STATE OF DELAWARE
EXECUTIVE DEPARTMENT
OFFICE OF MANAGEMENT AND BUDGET
Budget Development, Planning and Administration
State Planning Coordination

RE: PLUS review – 2008-09-11; Village Brooke North

According to the information received, you are seeking a rezoning of 394.39 acres for a 528,000 sq. ft. commercial center and 2100 homes.

Figure 1: Soil survey mapping in the immediate vicinity of Village Brooke North

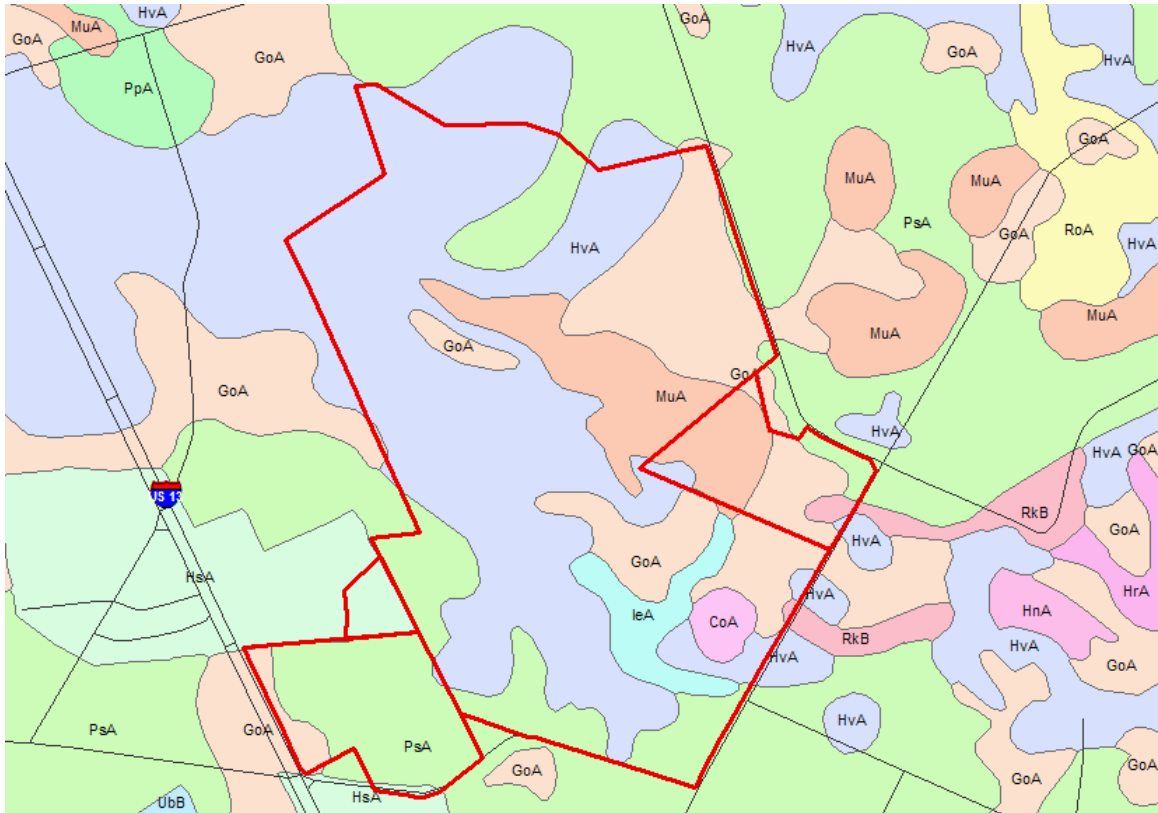
According to the Sussex County soil survey update, Ingleside (IeA), Pepperbox-Rosedale complex (PsA), Glassboro (GoA), Hurlock (HvA), Corsica (CoA), and Mullica (MuA) were mapped in the immediate vicinity of the proposed construction (See figure 1).

Ingleside is a well-drained upland soil that, generally, has few limitations for development. Pepperbox-Rosedale is moderately well to well-drained upland soil that has

moderate to few limitations for development. Glassboro is a somewhat poorly-drained soil transitional soil that is likely to have both upland and wetland soil components. Hurlock, Corsica, and Mullica are poorly to very poorly-drained wetland associated (hydric) soils that have severe limitations for development. Approximately 70 percent of the mapped soils were mapped as Hurlock, Corsica, and Mullica. These soils, as mentioned previously, have severe limitations for development and should be avoided.

Figure 2: Statewide Wetland Mapping Project (SWMP) mapping in the immediate vicinity of Village Brooke North

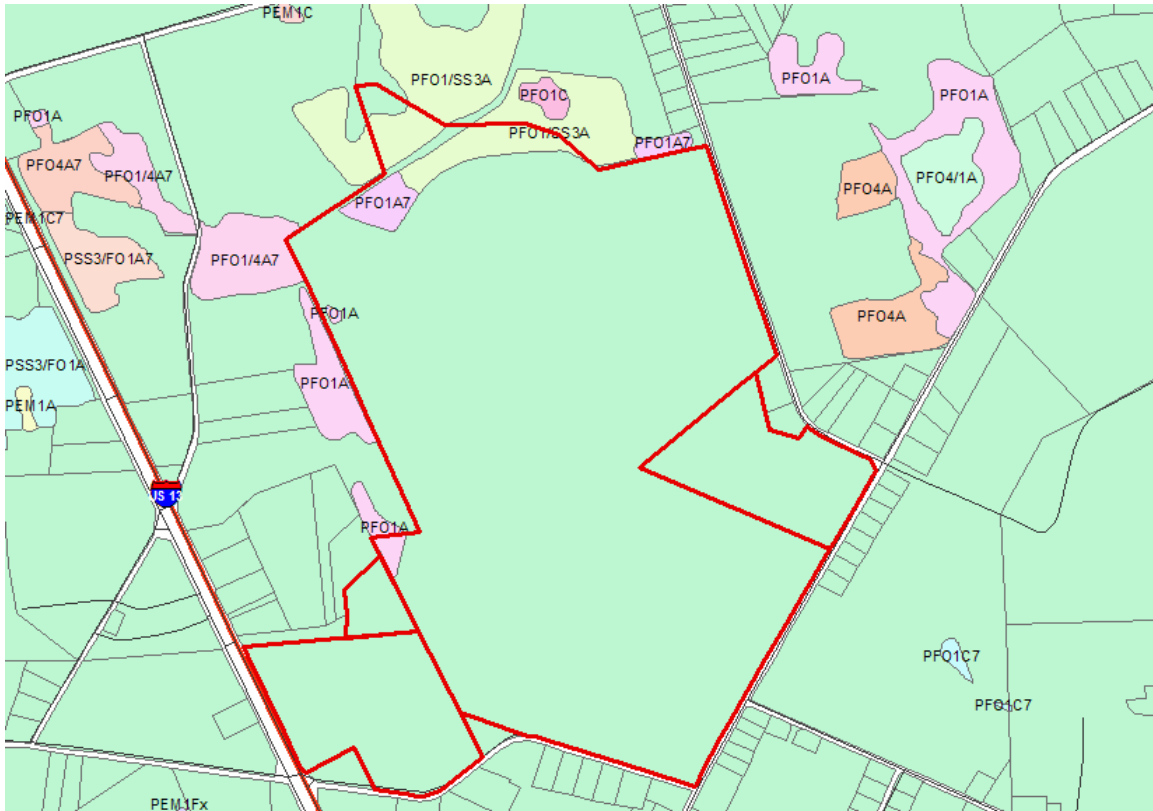
Based on Statewide Wetlands Mapping Project (SWMP) mapping, palustrine forested wetlands were mapped along much of the northern boundary and partially along the northeastern boundary of the proposed project (See figure 2). Please Note: Although the mapped hydric soils do not precisely match the occurrence of the mapped wetlands, this in no way negates the fact that wetland conditions still probably exist where these soils occur.

There are some blue line streams (part of Gum Branch and tributaries) on the property that will be impacted by the proposed development. These blue line feature(s) on the property are subject to the requirements of the State Subaqueous Lands Regulations and cannot be filled in without a permit from the Wetlands and Subaqueous Lands office. Options for the project include redesigning around the blue line features. The developer may be able to mitigate; however, to do so, they may have to reduce the size of the project.

DNREC could not find any record of a jurisdictional determination on the property. They may want to request one, as most developers do, to determine if all or just a portion of the blue line features are jurisdictional under State regulations. Additionally, the

SWMP maps show wetlands regulated by the Corps of Engineers on the property where there is proposed development. They need to contact the Corps of Engineers to get a jurisdictional determination for the property.
